Aug 24, 2018

Motor Business Unit,
Electromechanical Control Business Division,
Automotive & Industrial Systems Company,
Panasonic Corporation

Software Upgrade Notice for AC Servo Driver (MINAS A6SE/A6SF/A6SG Series)

No. 2) Setting range extension of analog input (AI1, AI2, AI3) offset

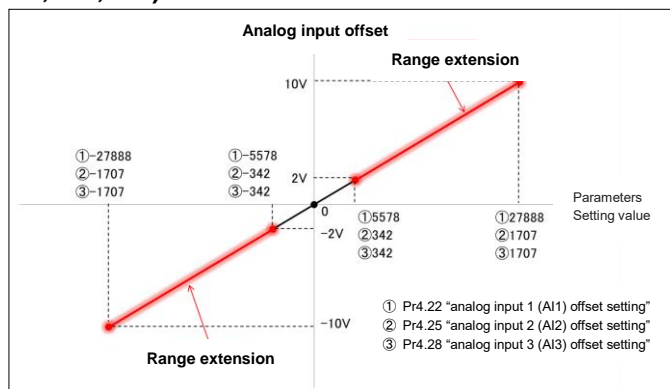
The setting range of offset adjustment value (Pr4.22, Pr4.25, Pr4.28) to the voltage applied to the analog input (AI1, AI2, AI3) has been expanded as follows.

±2V (Pr4.22: -5578 ~ 5578 [0.359 mV],
Pr4.24, Pr4.28: -342 ~ 342 [5.96 mV])

↓
±10V (Pr4.22: -27888 ~ 27888 [0.359 mV],
Pr4.24, Pr4.28: -1707 ~ 1707 [5.96 mV])

(Please see the chart to the right.)

Because this is an expansion of the set range, use of this function, as before, is possible without a change.
